GRANDVIEW CONDOMINIUM COMMUNITY

PROJECT: 12023-0022/PS/P0203-0010
REVISION: Revision #7
RECEIVED: 8/14/2026
PLANNING & ECONOMIC DEVELOPMENT DEPARTMENT

**Subject: Grandview Development along Auburn Road,
Site Plan Review #7
Plans dated July 29, 2026
ASTI File No. P25-0125.33**

SITE PLAN .pdf Markup Summary

UTILITY INFORMATION, AS SHOWN, INDICATES APPROXIMATE LOCATIONS AND TYPES OF EXISTING UTILITIES ONLY, AS DISCLOSED BY RECORDS PROVIDED TO THIS FIRM FROM THE VARIOUS UTILITY COMPANIES. NO GUARANTEE IS GIVEN OR IMPLIED AS TO THE COMPLETENESS OR ACCURACY THEREOF.

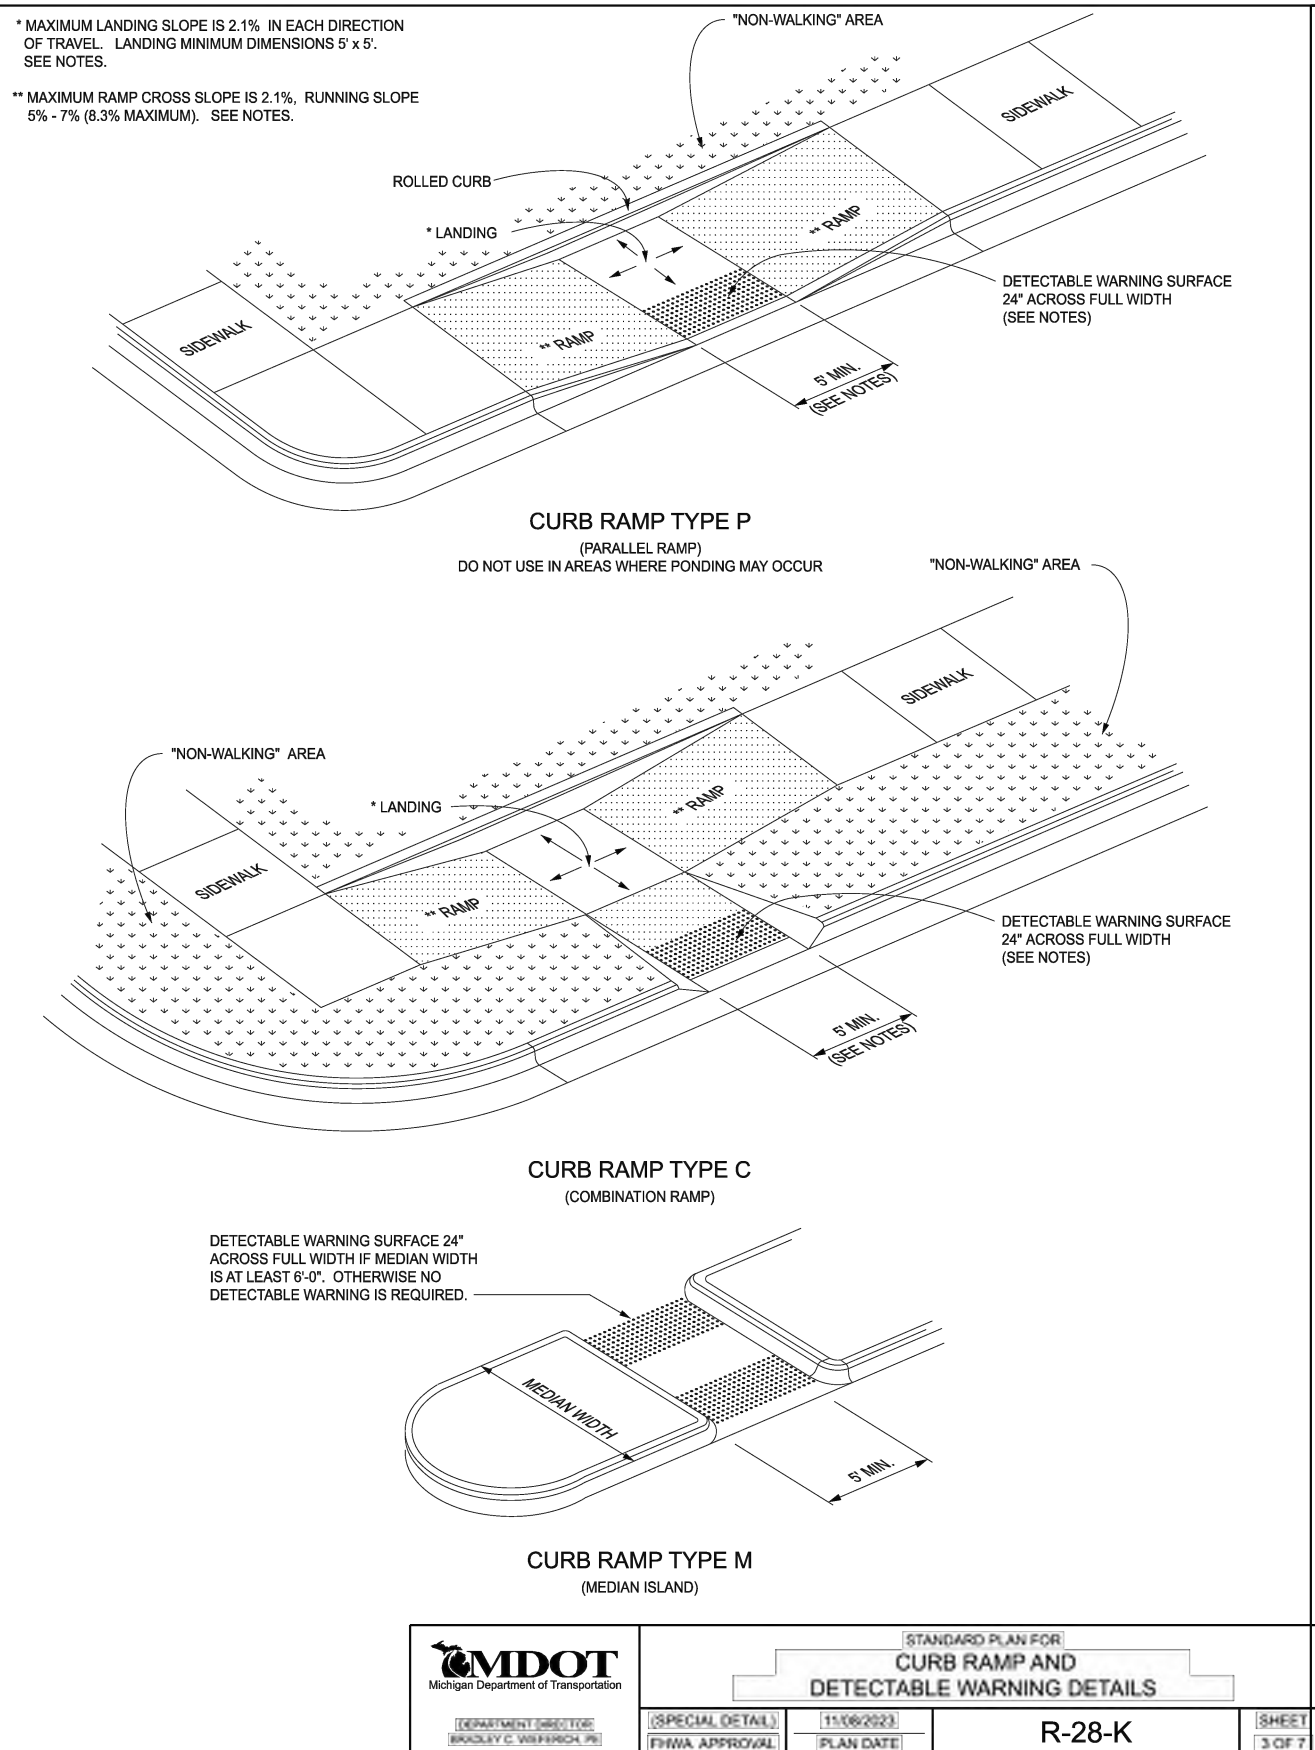
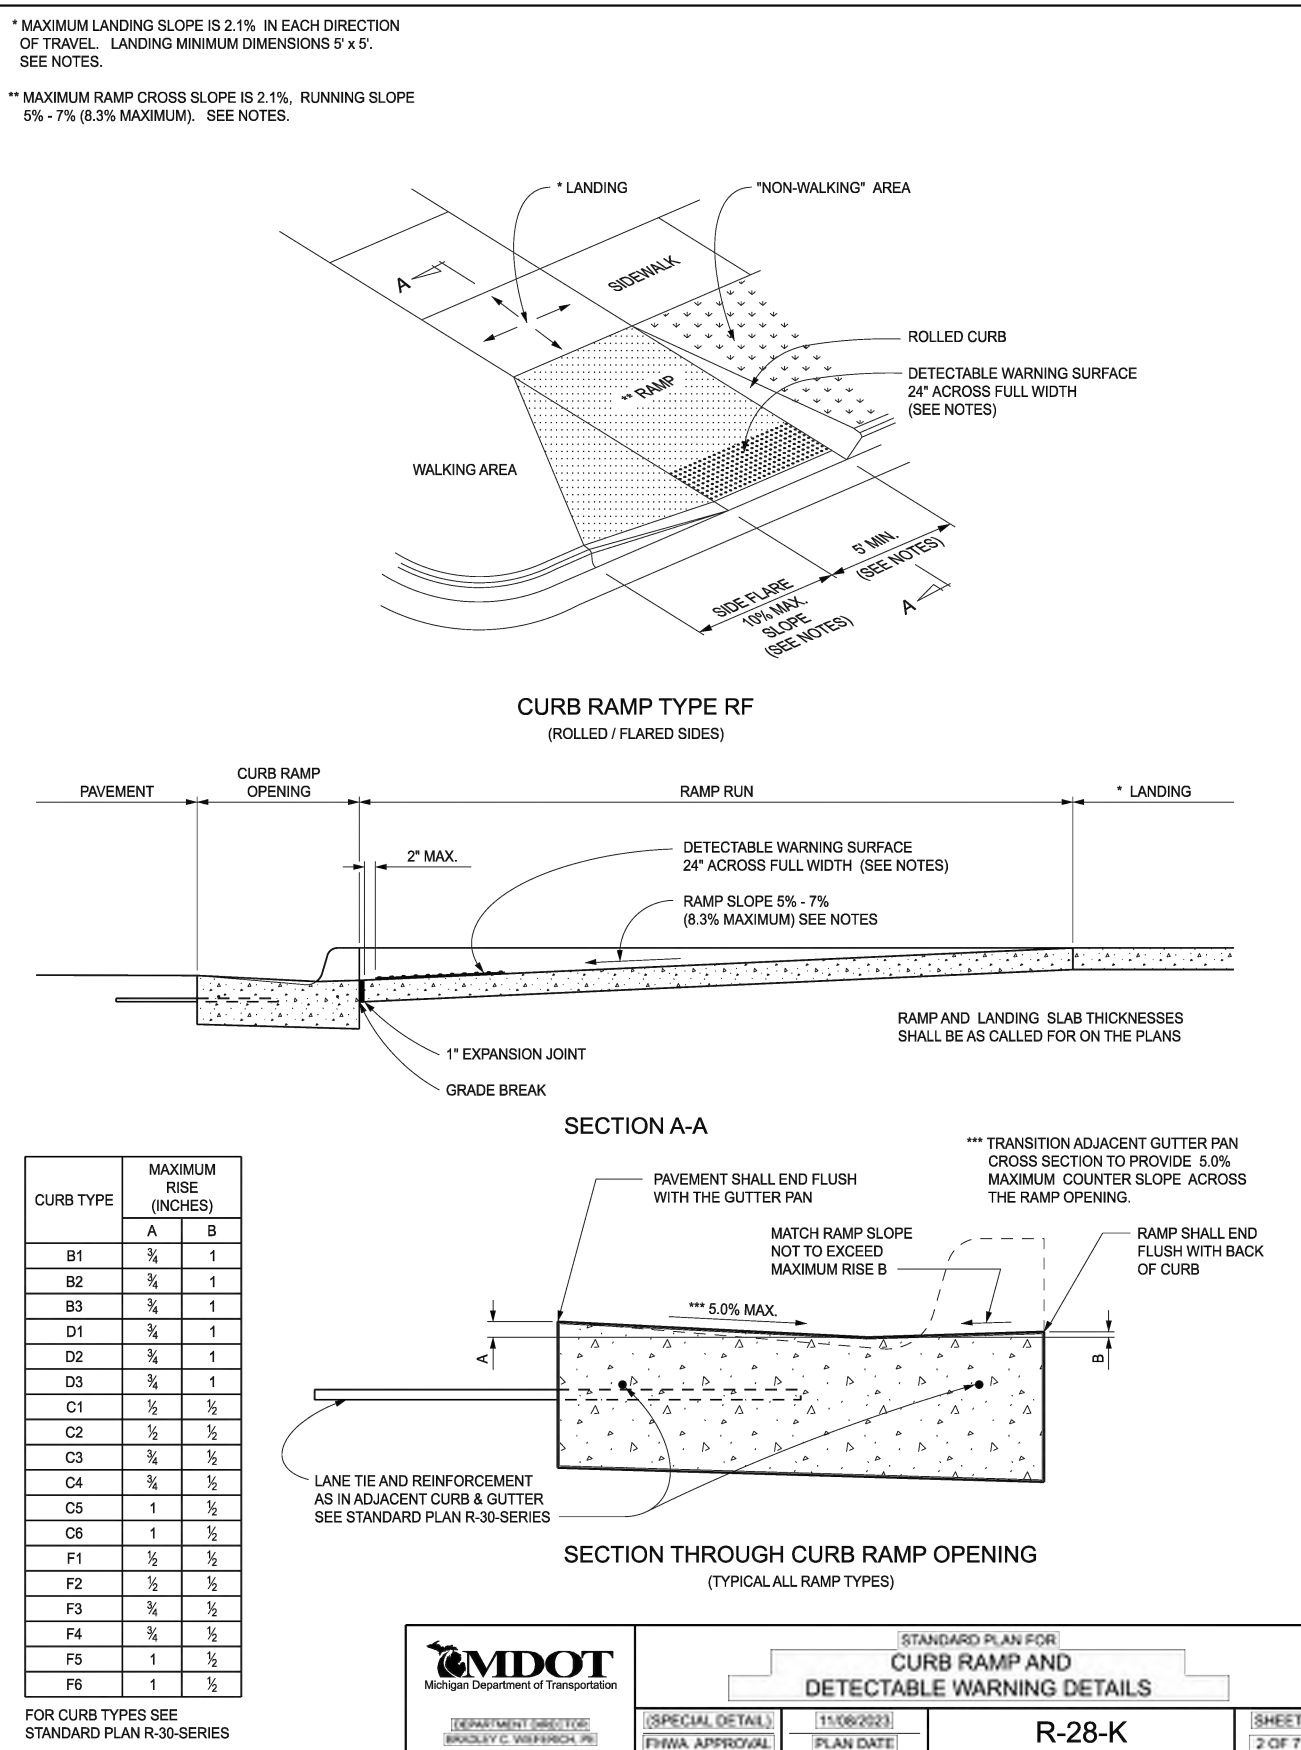
Add any crosswalk marking details here.
